# **Central Planning Authority**

**Agenda** for a meeting of the Central Planning Authority to be held on **17 January 2024 at 10:00am** in Conference Room 1038, 1st Floor, Government Administration Building, 133 Elgin Avenue

**CPA/03/24**

*Figure 1: Aerial Imagery showing the application site outlined in red (Source: Google Maps, Accessed 25 October 2023)*

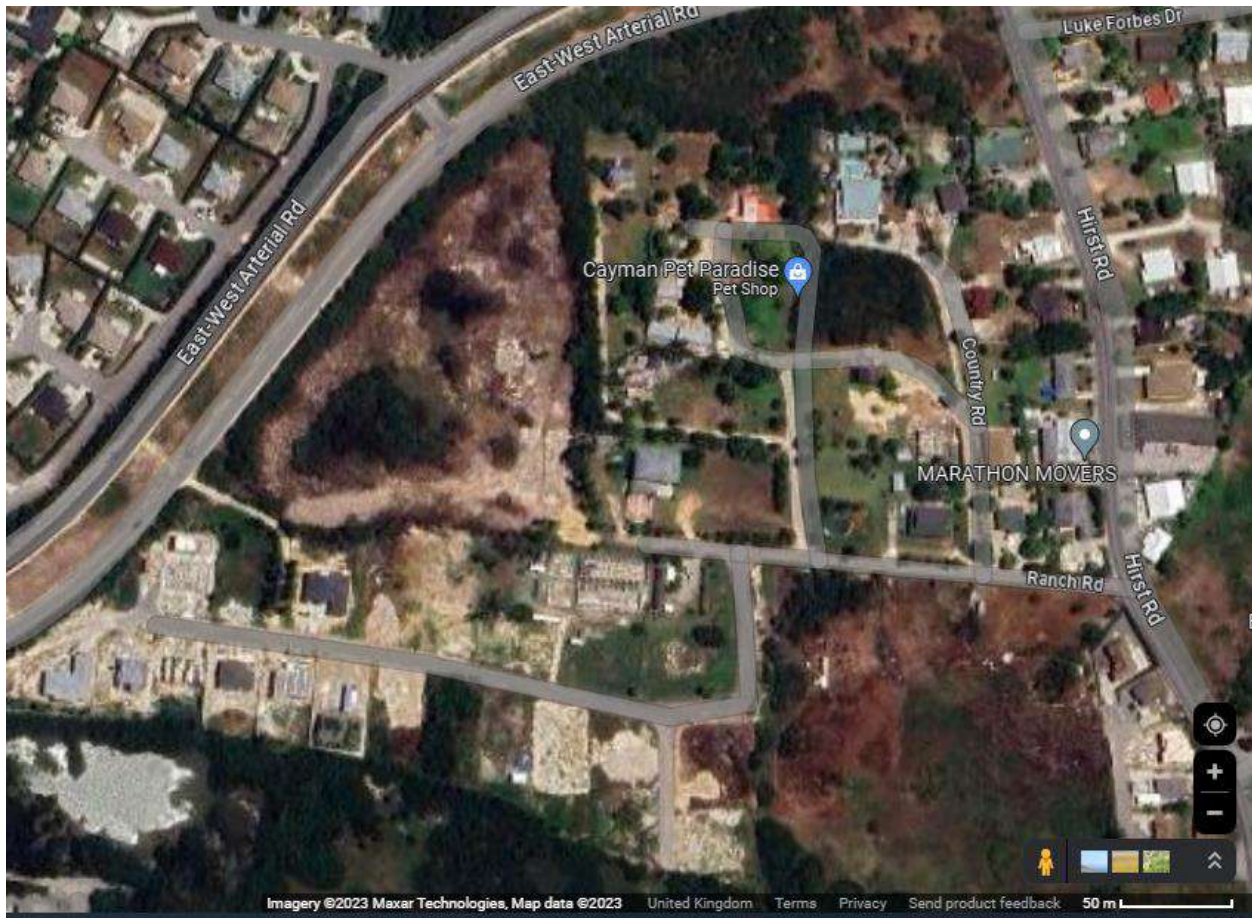
*The site was man-modified with regrowth of mangrove wetland habitat. However, google imagery (see Figure 1) shows the application site as already cleared. It is also noted that an enforcement file has been created for unauthorized land clearing of this site (Planning Ref: CE23-0104) in September 2023.*

*The site has already been cleared and therefore there is little opportunity to provide meaningful feedback. However, it is noted that the application site is part of a wider former-wetland and likely provides drainage capacity to the surrounding area. The clearing and filling of this parcel may increase the risk of flooding to the surrounding area.*

*Figure 1: Application site parcels are highlighted in light blue. Shown in the image is the car park in grey, the restrooms in yellow, the septic in black/dark grey, the cabanas in red and the 75ft coastal setback provided by the applicant as the red line.*

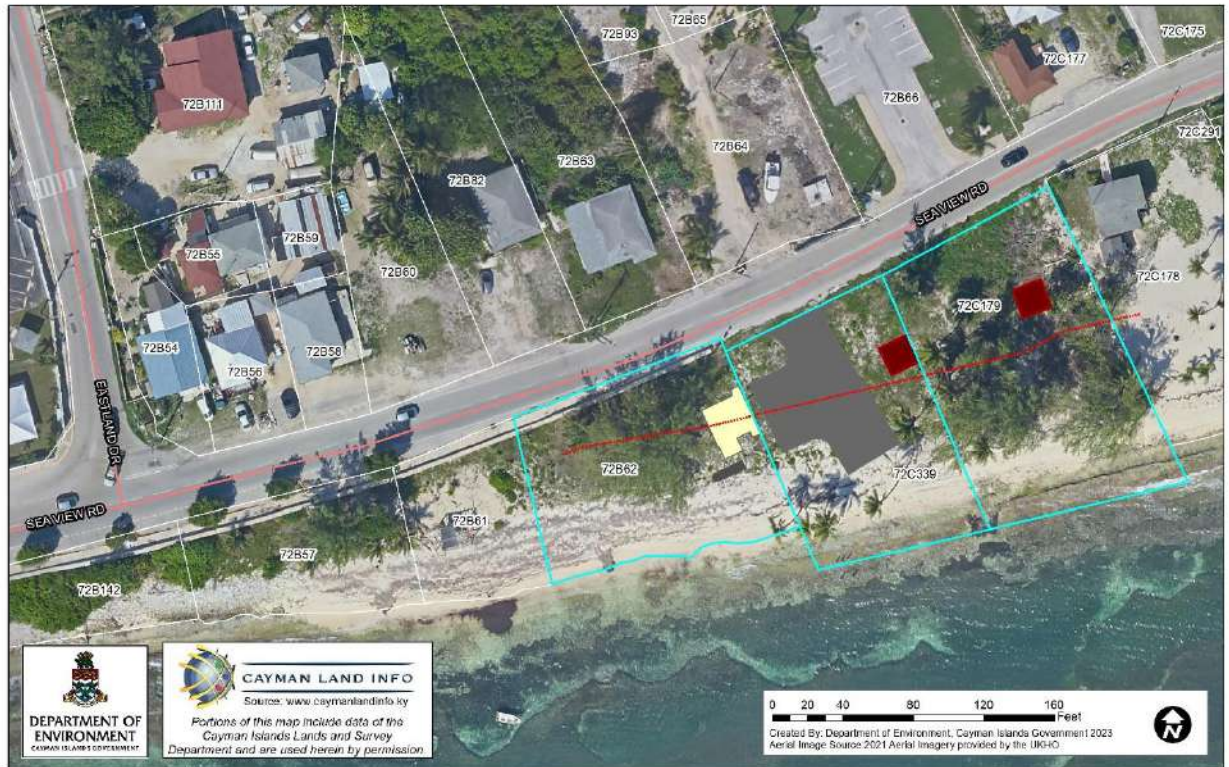
*The application site is predominantly man-modified with some coastal vegetation and some invasive vegetation. However, the beach of the site is also a turtle-nesting beach.*

*Figure 8: An example of suitable construction fencing to protect turtles (Source: DoE, 2022).*

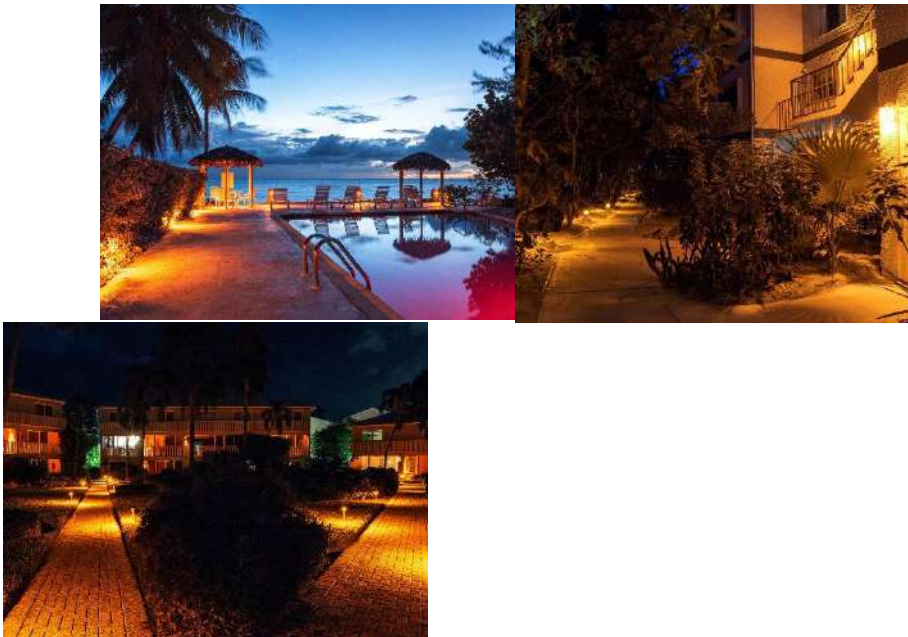
*Temporary beachside construction fencing must be:*

- *Located as far landward as possible to leave room/habitat for the turtles to nest during the work;*
- *Made from a sturdy/solid material like plywood with no gaps (i.e. not chainlink fencing or the orange plastic fencing with holes as hatchlings can crawl through these and adults can knock it down or become tangled);*
- *Embedded at least 2 feet into the sand so that turtles cannot dig it out or crawl under;*
- *Installed in a manner that any nailing of the wood will be done so that the sharp ends are located on the landside of the fencing to prevent injury to turtles;*
- *Suitable to contain all excavated material, construction materials and demolition waste landward of the fencing; and*
- *Installed so that it does not block public access along the foreshore and **not** installed along or seaward of the Mean High Water Mark.*
